Access Compliance Report

Public Rights-of-Way

(Curb Ramps)

Intersection ID: 48366	Main Street: WHEATFIELD_RD	Cross Street: SULKY_PLOUGH_RD	Location: SE
ADA ID: A9C44265DE7F	Ramp Type: PerpDiag	Initial Pass/Fail: Fail	Overall Compliance: No
Severity Score: 13.75			
Codes/Mitigation Info/Possible Solution		Field Measurements/Component Compliance

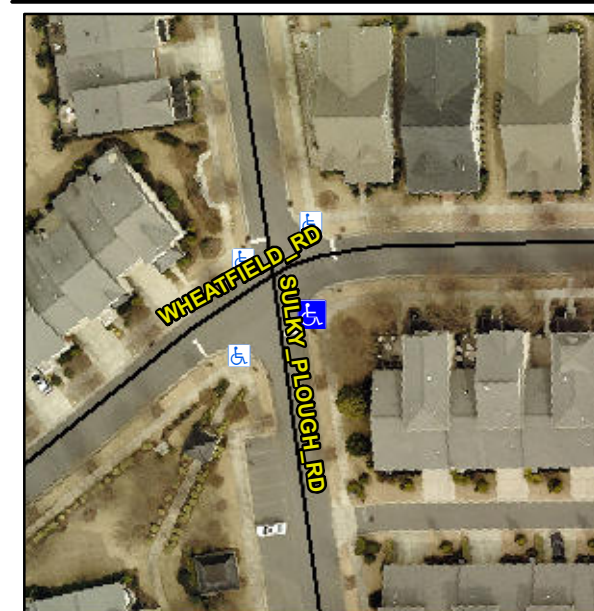
Not Found, R304.2.2, R304.5.3

Compliance	Description	Data	Compliance	Description	Data
N/A	Ramp Length (in)	72.0	No	Ramp Slope (%)	9.7
Yes	Ramp Width (in)	48.0	No	Ramp XSlope (%)	4.7
N/A	Flare Type LT	N/A	N/A	Flare Type RT	N/A
N/A	Flare Slope LT (%)	N/A	N/A	Flare Slope RT (%)	N/A
N/A	Flare Traversable LT?	N/A	N/A	Flare Traversable RT?	N/A
N/A	Landing Length (in)	N/A	N/A	DWS Provided?	N/A
N/A	Landing Width (in)	N/A	N/A	DWS Contrast?	N/A
N/A	Landing Slope (%)	N/A	N/A	DWS Length (in)	N/A
N/A	Landing X Slope (%)	N/A	N/A	DWS Full Width?	N/A
N/A	Landing Curb? (Y/N)	N/A	N/A	DWS Offset (in)	N/A
N/A	Shared Landing?	N/A			
N/A	Gutter Ponding?	N/A	N/A	Gutter Slope (%)	N/A
N/A	Gutter Lip Ht (in)	N/A	N/A	Gutter X Slope (%)	N/A
N/A	Painted X Walk1?	No	N/A	Painted X Walk2?	No
	X Walk 1 Direction	To N		X Walk 2 Direction	To W
N/A	X Walk 1 Width (in)	N/A	N/A	X Walk 2 Width (in)	N/A
	X Walk 1 Slope (%)	4.8		X Walk 2 Slope (%)	0.6
	X Walk 1 X Slope (%)	1.4		X Walk 2 X Slope (%)	2.9

Remove & Replace Curb Ramp With Two New Directional Ramps or Equivalent.
